CERTAIN OBJECTORS' PETITION TO RECONSIDER

IN THE MATTER OF FREMONT PAVING & REDI-MIX INC.'S PUEBLO COUNTY
AGGREGATE PROJECT APPLICATION (File No. M-2016-009)

Comments on Pueblo County Aggregate Project
January 9, 2017

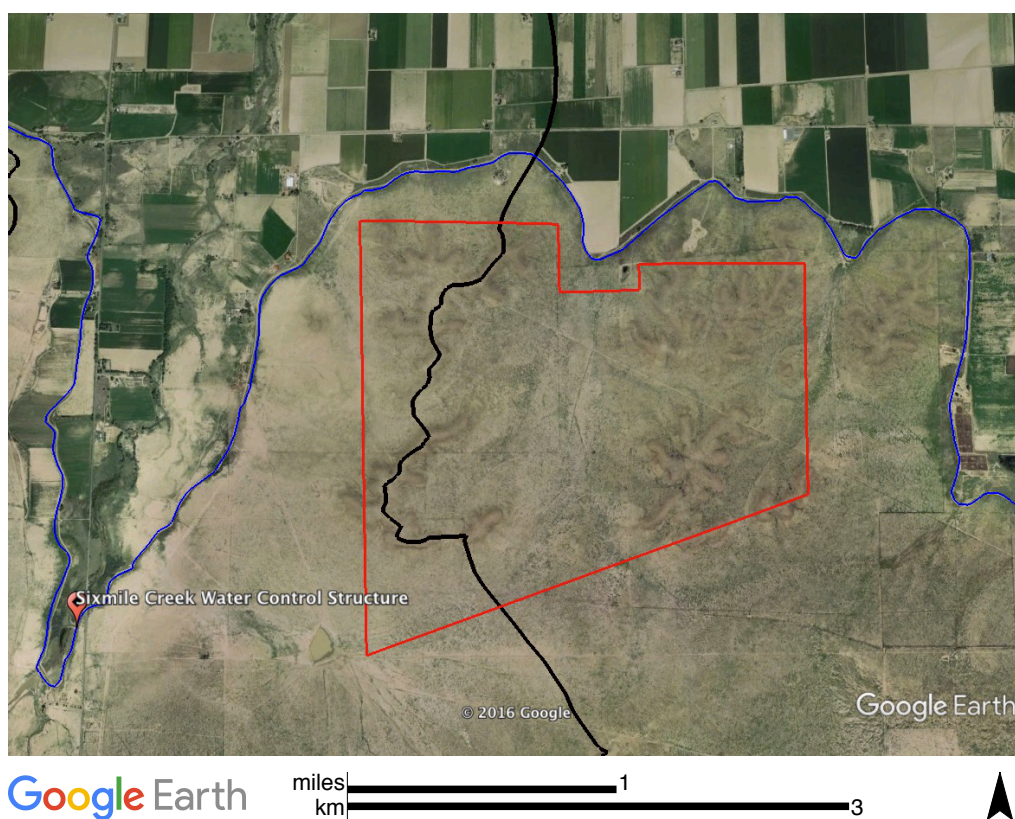
Figure 1 shows the boundary of the Pueblo County Aggregate Project (red polygon) as proposed in the map accompanying the application for discharges associated with sand and gravel mining and processing (Appendix 1). The project area overlaps two sub watersheds of the Arkansas River (HUC 110200021203, Sixmile Creek, and HUC 110200050301, Boone Creek-Arkansas River) with the Bessemer Ditch transecting both watersheds and channeling runoff to the Huerfano River. Figures 2 and 3 show that the project area is upslope of the Bessemer Ditch. Storm water runoff will enter the Bessemer Ditch both to the west and north-west via runoff into the Sixmile Creek watershed and to the north into the Boone-Creek-Arkansas River watershed. Furthermore, an intermittent creek (Reach Code: 11020005013496) drains the middle of the project area into Bessemer Ditch, creating a direct flow path of storm water runoff from the proposed processing facilities and overburden storage areas into the Bessemer Ditch.

Given that the Bessemer Ditch is an immediate receiving water body for storm water discharge from the project site, I was surprised that the application permit did not include information on storm water quality controls. The mining operations, processing facility, and overburden storage will create elevated risk of erosion and sedimentation in the receiving waters, especially when exposed to intense rainfall events. One such event occurred in August 2013. Excess flows from intense thunderstorms forced diversion of flow from the Bessemer Ditch into Sixmile Creek (location of diversion structure is indicated in Figure 1) to prevent flooding and damage to the ditch. By August 23, 2013, significant damage occurred through bank erosion, flood damage to property, and damage to downstream bridges. Increasing sediment load in the Bessemer Ditch will lead to decreased flow volume and increased risk of ditch flooding. Without proper on-site storm water management, the project could pose a substantial risk to properties along Sixmile Creek and properties adjacent to the Bessemer Ditch.
